MORE PEOPLE BIKING  
MORE OFTEN

# Traffic Calming on Osborne and River

Executive Policy Committee  
April 16, 2024

**Figure 1:** Design drawings from River-Stradbrook protected bike lanes tender, with conflict point between the protected bike lane and right turning vehicles highlighted.

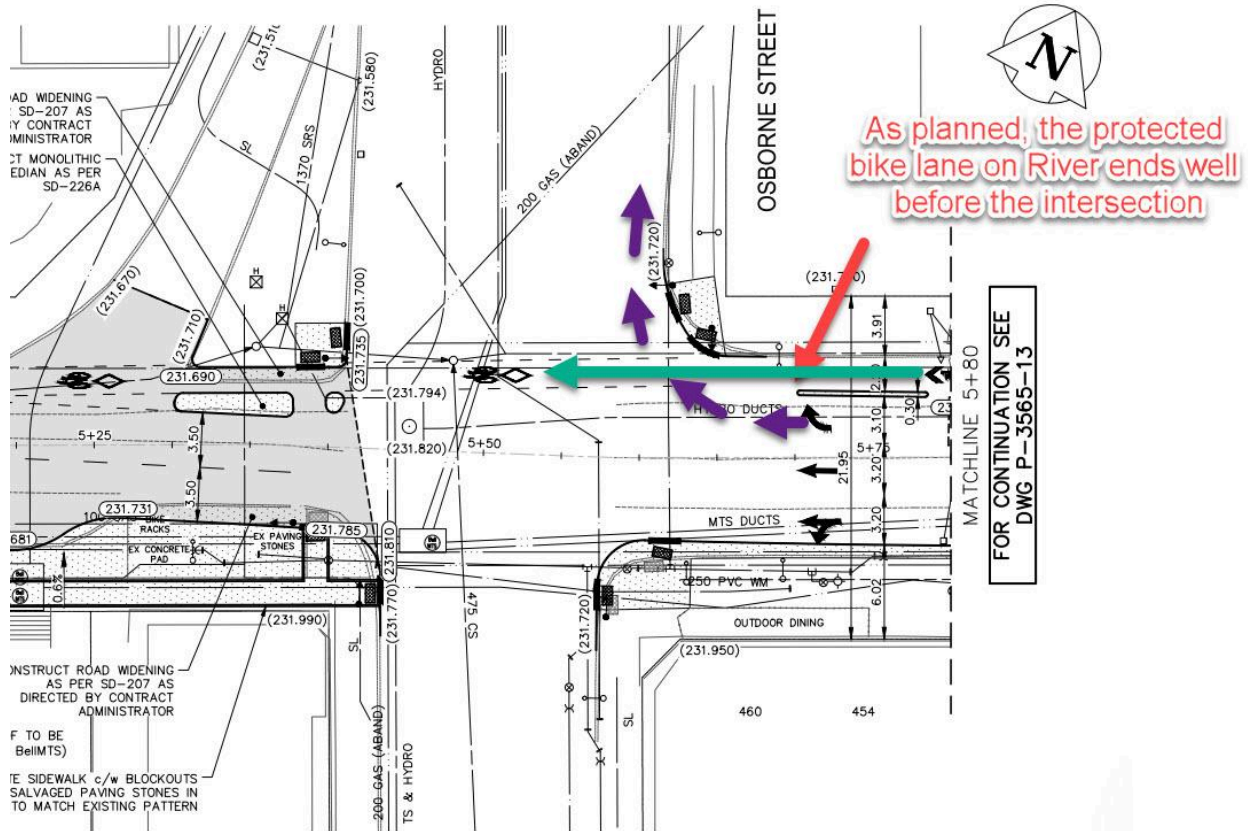
A first suggestion to improve safety and convenience of the intersection is to prioritize the safety of pedestrians and people on bikes by reducing the conflict posed by traffic turning right off of River Ave onto Osborne across the protected bike lane being constructed this spring/summer.

We feel that a protected intersection design should have been used here. The expectation is that there will be high volumes of bicycle traffic through this intersection, as well as high foot traffic along with a heavy right turn movement from vehicles (an unofficial number of 1,000 right turns per day was provided by transit staff in discussion of the intersection during the April 9th Public Works Committee meeting).

We believe that a protected intersection could be provided in this corner of the intersection through the elimination of the right turn lane on River Ave approaching Osborne. This would:

- Allow the bus stop to remain at the corner of River and Osborne rather than be backed up to the start of the right turn lane.
- Reduce the risk of right hook collisions with people on bikes heading across Osborne St
- Reduce the crossing distance of River Ave
- Provide a second ramped entrance to the bus platform
- Square up the crossing of Osborne on the north side of River

We ask that a protected intersection be implemented as part of the River/Stradbrook protected bike lanes project to reduce the right turn conflict at the corner of River and Osborne St. Efforts to reach out to organizations serving people with visual impairment, as well as organizations serving people with mobility challenges should be included in the project.

**Figure 6:** Reducing the cycle lengths along the Osborne Corridor would reduce pedestrian wait times while providing consistent crossing opportunities and a more permeable walking network.

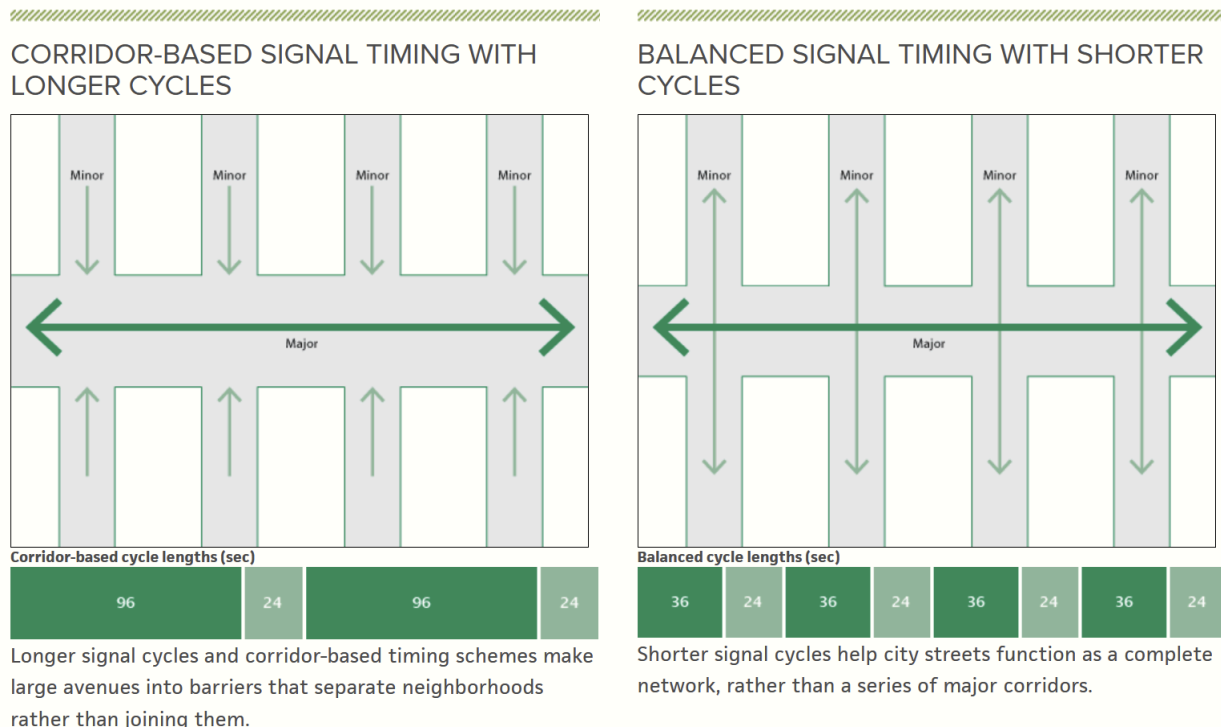
While the study makes the case that a pedestrian scramble would not provide the hoped for benefit to pedestrians, it does not look into any other options to improve pedestrian safety, convenience, or comfort of pedestrians. A well-established best practice in this regard is to reduce cycle lengths to limit wait times. Ideally, signal cycle lengths should be minimized to promote consistent crossing opportunities and create a more permeable pedestrian environment suitable for the pedestrian nature of Osborne Village.

Short cycle lengths of 60–90 seconds are ideal for urban areas and permit frequent gaps and consistent crossing opportunities. The current 90 second signal cycle length identified in this report is at the maximum range considered ideal for an urban area. The report needs to review options to reduce the signal cycle length to 70 or 75 seconds. Doing so will likely increase pedestrian compliance while increasing the convenience and comfort of people accessing shops along Osborne St. These changes could be applied across the full length of Osborne St to extend this benefit through the Lord Rovers and South Osborne neighbourhoods where similar concerns have arisen.

**Figure 7:** Adding a continuous sidewalk to promote speed reductions in a smart channel design. Note that the above example includes a bike lane along the smart channel (A) that would not be part of the design at River and Osborne.

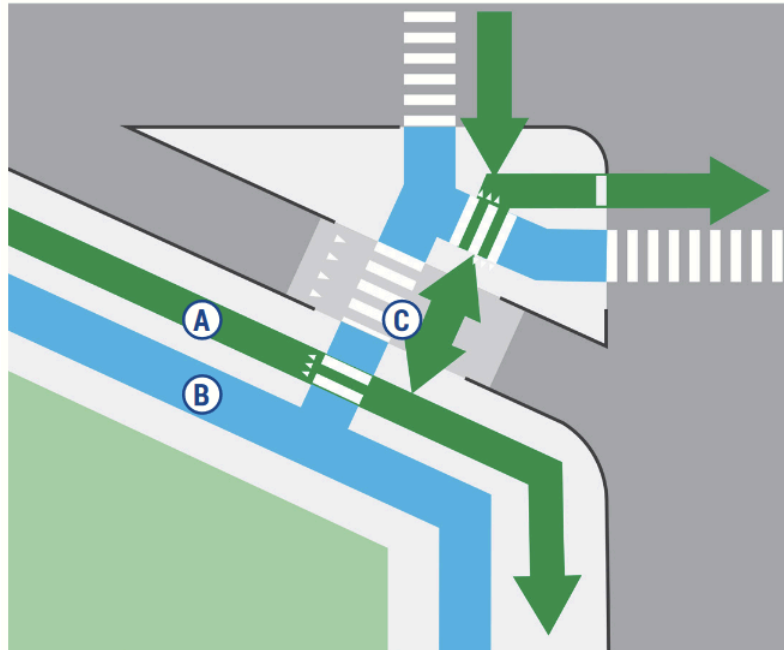
While the report recognizes continuous sidewalks as an intervention having a “positive outlook” to be reviewed as part of an upcoming update to the Transportation Standards Manual, it makes no recommendations to include even a pilot for such an intervention here, despite the direct call for such a pilot in the motion that triggered this study.

Cities such as Edmonton are making wide use of continuous sidewalks as part and parcel of their regular maintenance work. Guidance on Smart Channels, as provided in the City of

Ottawa's Protected Intersection Design Guide clearly calls for the inclusion of continuous sidewalks as part of Smart Channel design as well. Indeed, the Osborne Village Secondary plan also calls for the use of Raised Crossings.<sup>5</sup>

We ask that a pilot of a continuous sidewalk be implemented as part of the River/Stradbrook protected bike lanes project. Efforts to reach out to organizations serving people with visual impairment, as well as organizations serving people with mobility challenges should be included in the project.

**Figure 8:** Truck apron integration in various corner designs

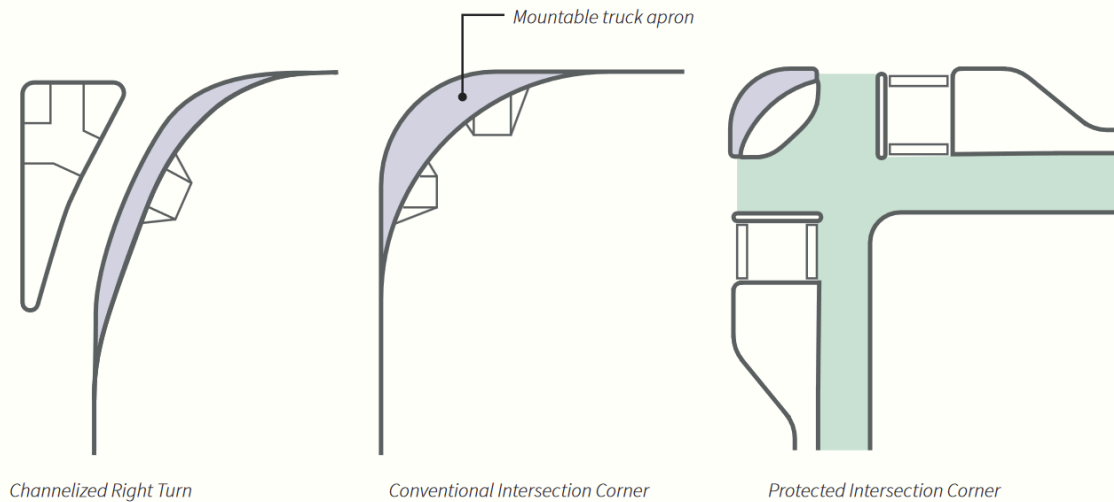
Our final request is that truck aprons be considered instead of paint to tighten up the turning angle in the smart channel design of the right turn slip lane off of Osborne onto River Ave. Such a design is commonplace, and ensures increased compliance with the restricted turning radius of the smart channel.

As such a design would be new for Winnipeg, efforts to reach out to organizations serving people with visual impairment, as well as organizations serving people with mobility challenges should be included in the project.
